Docket Number:	79-AFC-05C
Project Title:	Compliance - Application for Certification for PG&E Geysers Unit 16 (78-NOI-6)
TN #:	222036
Document Title:	PTA Geysers-16, Quicksilver, Diesel Generator for Cooling Tower Wetting System
Description:	Petition to Amend (PTA) to install a permanent diesel generator for the cooling tower wetting system
Filer:	Patty Paul
Organization:	Geysers Power Company, LLC
Submitter Role:	Applicant
Submission Date:	12/21/2017 12:10:14 PM
Docketed Date:	12/21/2017

Subject: Permits - Minor Improvements to Fire Prevention Cooling Tower Wet-down Systems at
GPC Quicksilver Power Plant Geysers Unit 16 Docket: 79-AFC-05C
GPC Socrates Power Plant Geysers Unit 18 Docket: 79-AFC-03C
GPC Grant Power Plant Geysers Unit 20 Docket: 82-AFC-01C

CONSOLIDATED PETITION FOR A STAFF APPROVED MODIFICATIONS

Figure 1
Flow Diagram Showing Emergency Standby Wet Down Pump Diesel Drive Engine
Cummins Model CFP7EVS-F40

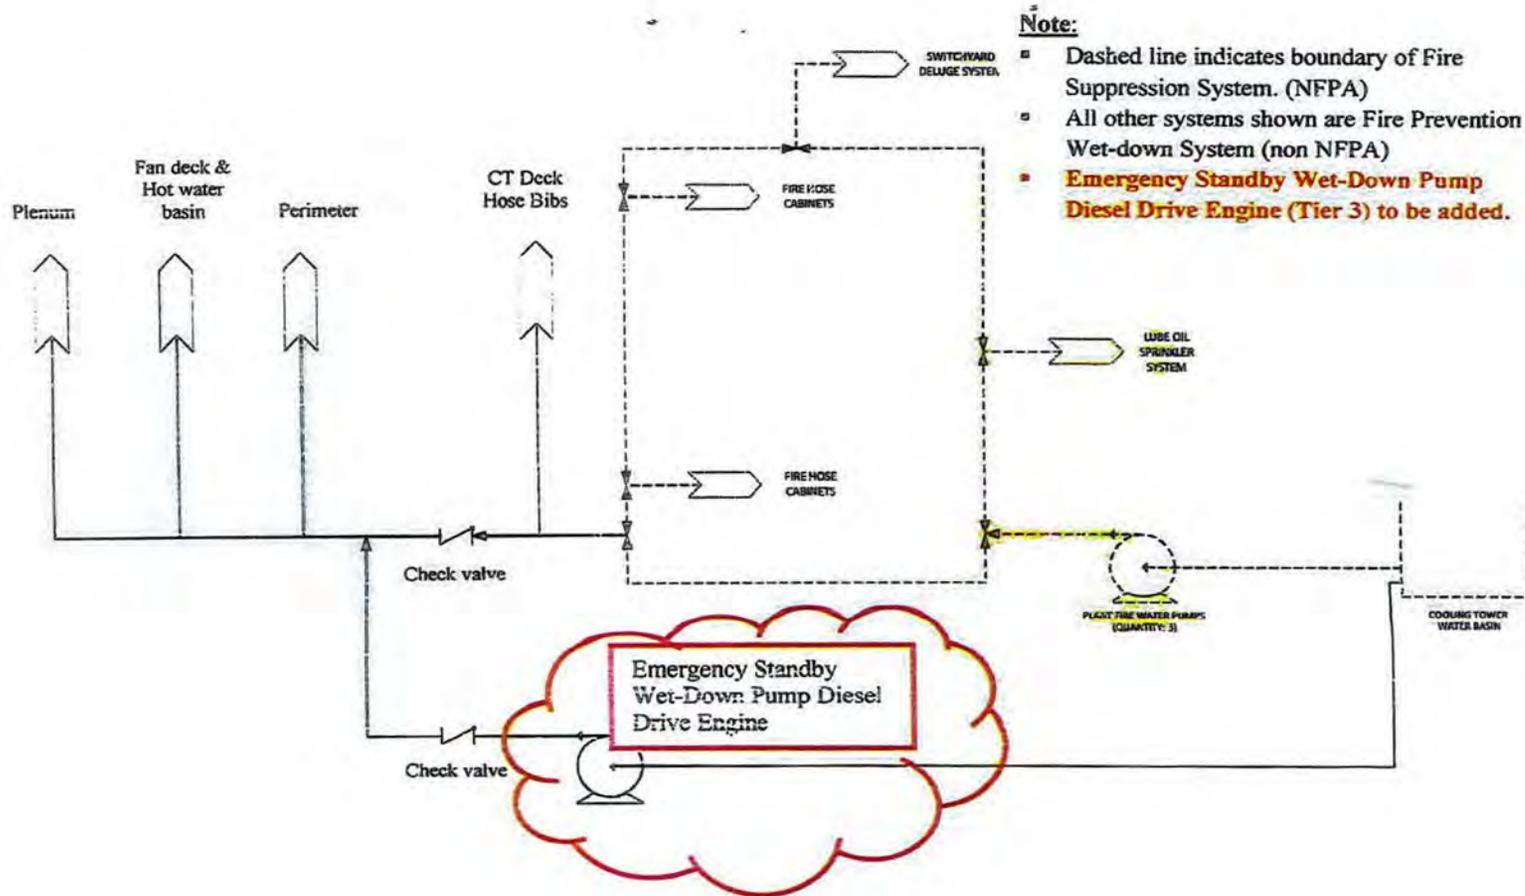
A permanent emergency standby wet down pump diesel drive engine is being added for use in the event of a plant evacuation due to the threat of an approaching wild land fire. The location of the emergency standby wet down pump diesel drive engine is shown adjacent to the cooling tower circulating water pit on the Socrates Power Plant Plot Plan (**Attachment 1**).

The emergency standby wet-down pump diesel drive engine will be manually started prior to evacuation of the power plant due to an approaching wild land fire to provide continued wet down of the cooling tower for approximately 24 hours or longer depending on fuel consumed. Particulate and other exhaust emissions resulting from the operation of the diesel engine would be consistent with manufacturer's specifications for this Tier 3 engine. The exhaust emissions from the engine during emergency use would be virtually undetectable amidst the combustion emissions resulting from an uncontrolled wild land fire.

Figure 1
Flow Diagram Showing Emergency Standby Wet Down Pump Diesel Drive Engine
Cummins Model CFP7EVS-F40

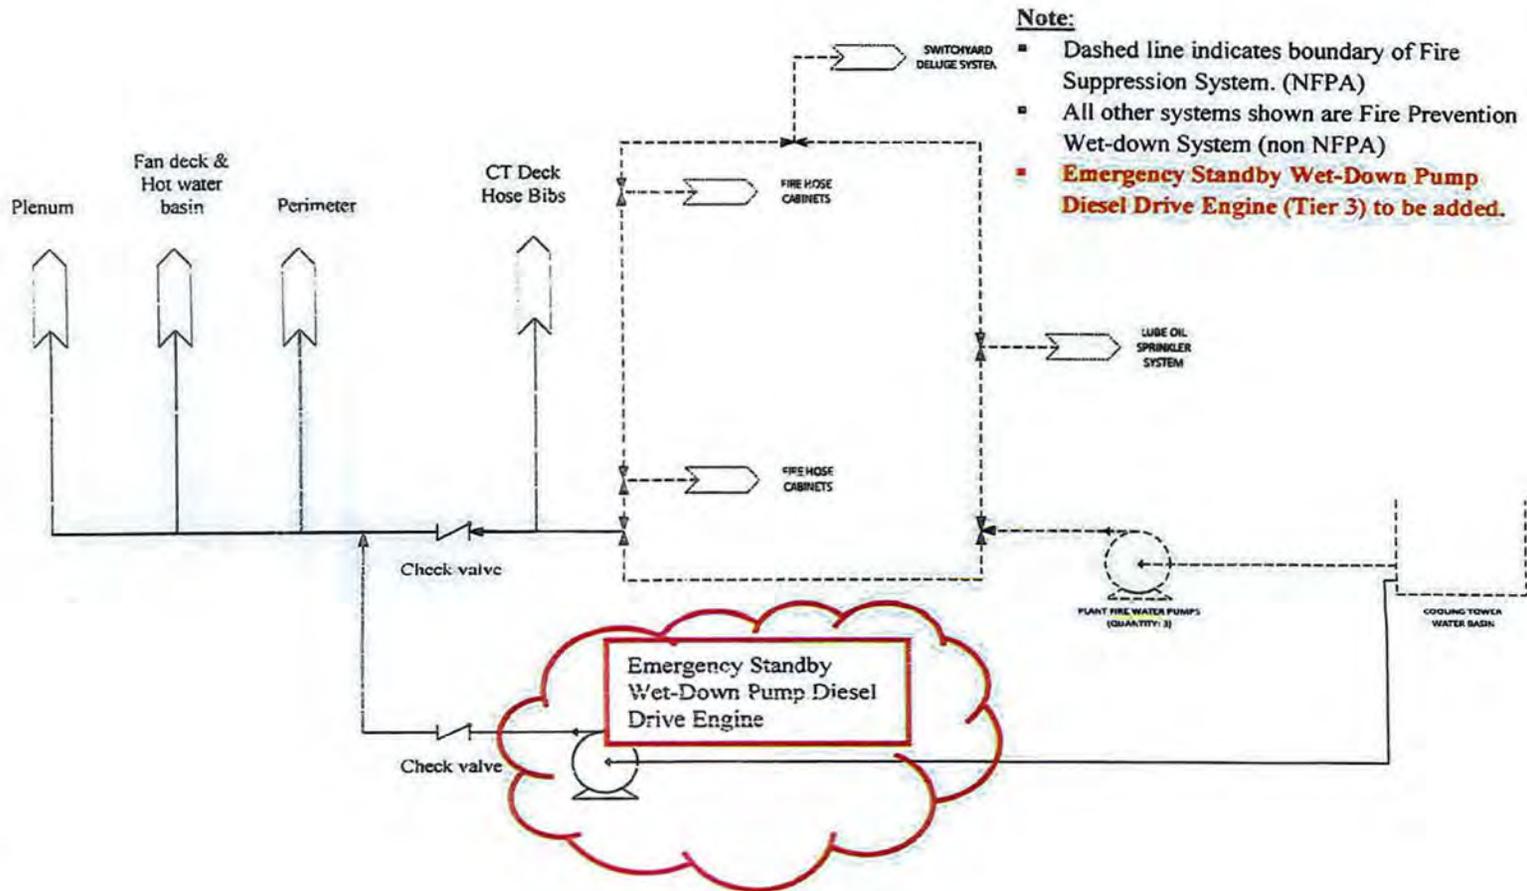
A permanent emergency standby wet down pump diesel drive engine is being added for use in the event of a plant evacuation due to the threat of an approaching wild land fire. The location of the emergency standby wet down pump diesel drive engine is shown adjacent to the cooling tower circulating water pit on the Grant Power Plant Plot Plan (**Attachment 1**).

The emergency standby wet-down pump diesel drive engine will be manually started prior to evacuation of the power plant due to an approaching wild land fire to provide continued wet down of the cooling tower for approximately 24 hours or longer depending on fuel consumed. Particulate and other exhaust emissions resulting from the operation of the diesel engine would be consistent with manufacturer's specifications for this Tier 3 engine. The exhaust emissions from the engine during emergency use would be virtually undetectable amidst the combustion emissions resulting from an uncontrolled wild land fire.

Figure 1
Flow Diagram Showing Emergency Standby Wet Down Pump Diesel Drive Engine
Cummins Model CFP7EVS-F40

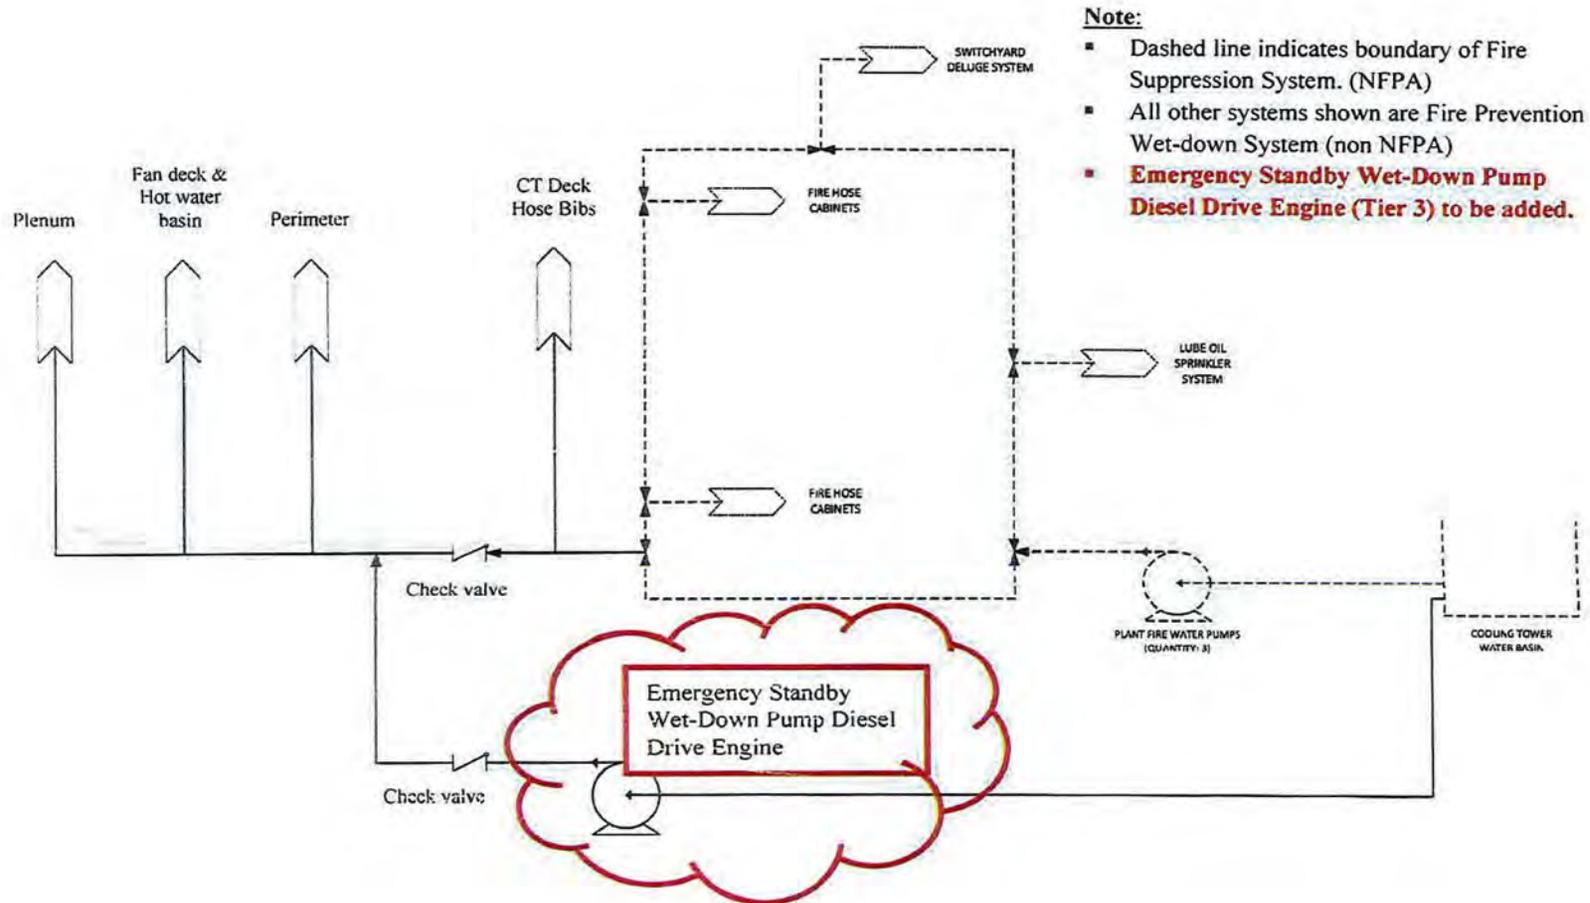
A permanent emergency standby wet down pump diesel drive engine is being added for use in the event of a plant evacuation due to the threat of an approaching wild land fire. The location of the emergency standby wet down pump diesel drive engine is shown adjacent to the cooling tower circulating water pit on the Quicksilver Power Plant Plot Plan (**Attachment 1**).

The emergency wet down pump diesel drive engine will be manually started prior to evacuation of the power plant due to an approaching wild land fire to provide continued wet down of the cooling tower for approximately 24 hours or longer depending on fuel consumed. Particulate and other exhaust emissions resulting from the operation of the diesel engine would be consistent with manufacturer's specifications for this Tier 3 engine. The exhaust emissions from the engine during emergency use would be virtually undetectable amidst the emissions resulting from an uncontrolled wild land fire.
